Turf Soccer Field

ADDENDUM NO. 1

Synthetic Turf Specifications

CHAIN-LINK FENCE

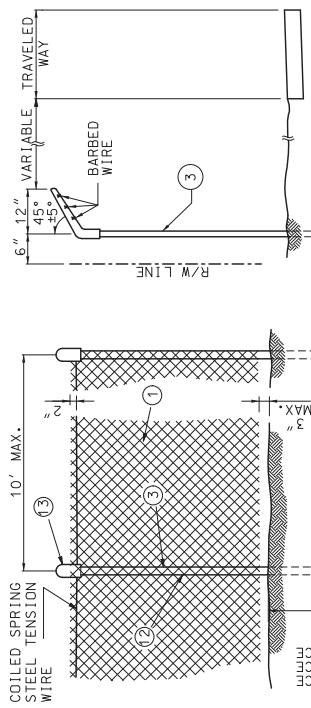
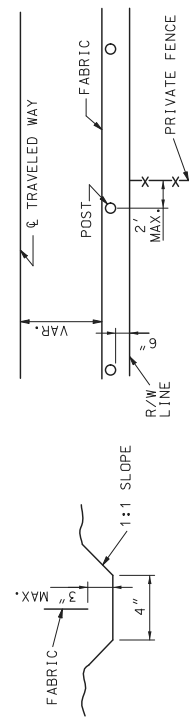
See attached standard drawing for fencing details

Turf Soccer Field

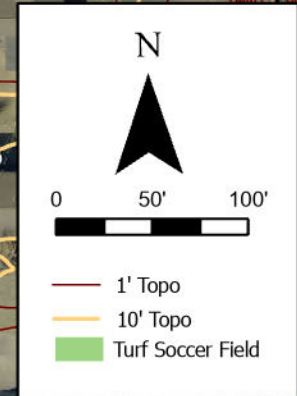
See the attached map for details of the final dimensions. 115 yards X 75 yards playing surface with a 5 yard buffer area.
